UNITED STATES PATENT AND TRADEMARK OFFICE

Office Action Summary	Application No. 10/567,068	Applicant(s) EDWARDS, MARTIN J.	
	Examiner GRANT D. SITTA	Art Unit 2629

DETAILED ACTION

FIG. 7

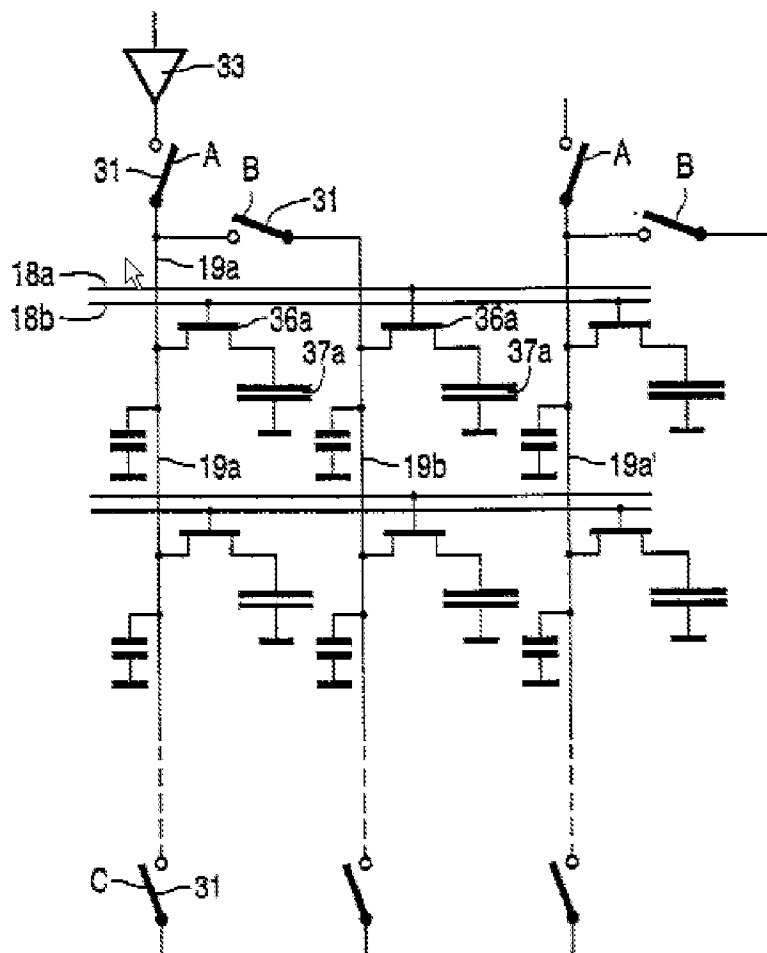
11. Examiner thanks Applicant for the well written response, however, examiner respectfully disagrees. Applicant asserts the prior art of record fails to teach "wherein the first and second capacitances of a digital to analogue conversion means comprise two column address conductors that are both associated with the same colour of picture elements." (Remarks, pg 5, 2nd ¶). A person of ordinary skill in the art, when applying the techniques of arrange color pixels as taught by Parks to the digital to analog conversion scheme of Edwards would teach the elements of the current application. Fig. 2 of the current application shows schematically part of a D/A conversion means in a know display device, as described in (pg 8, lines 4-20) WO 02/21496 / PG PUB 2002/0054005 (Examiner notes Fig 7 of Edwards 2002/0054005 does not have the color labels).

Edwards fails to teach wherein the D/A drives the same color element for different columns.

FIG. 4

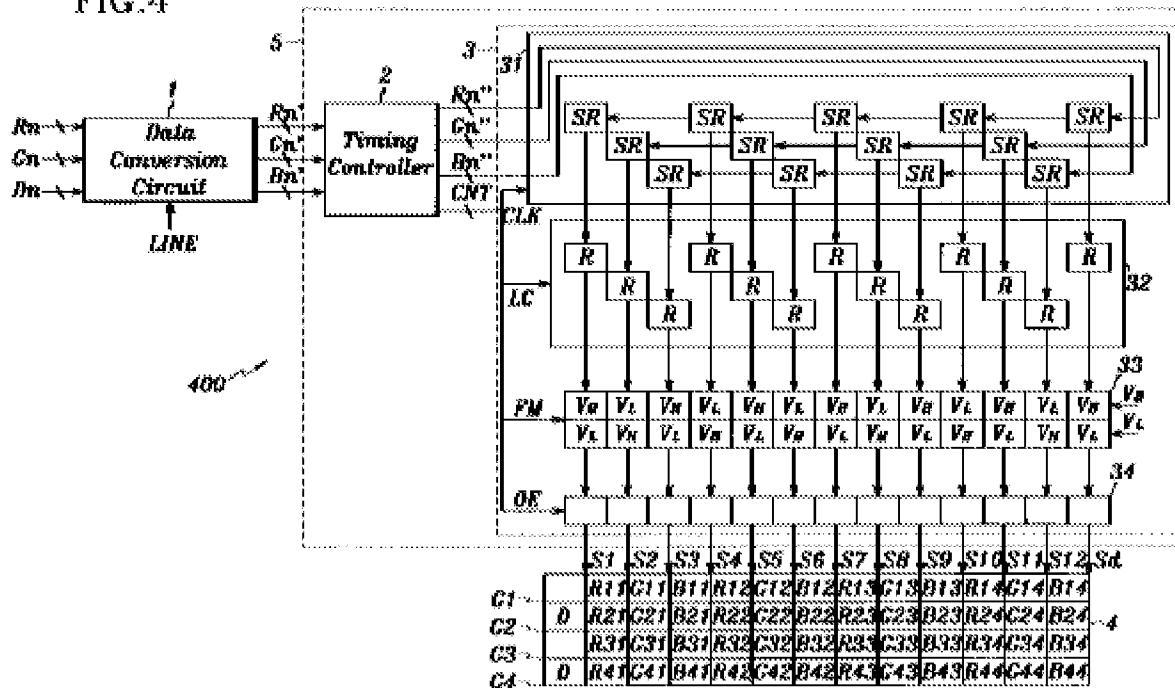
However, Parks teaches a technique to a system and method wherein picture elements in a column are of the same colour and adjacent columns of picture elements are of different colours (fig. 4 R_n", G_n" and B"), i.e. a driving means that groups common color columns. Examiner notes each column is made of a single color that alternates R, G, and B, while each color is group above to R_n", G_n" and B". The colors

are often grouped because of common characteristics associated with the different colors.

It would have been obvious to one of ordinary skill in the art, at the time of the invention, to modify Edwards such that the picture elements in a column are of the same colour and adjacent columns of picture elements are of different colours as taught by Parks in order to drive a color display with reduced power consumption, since each column of color can be addressed together, as stated in (col. 2, lines 22-45 of Park) and to decrease circuit complexity for ease of manufacturing.
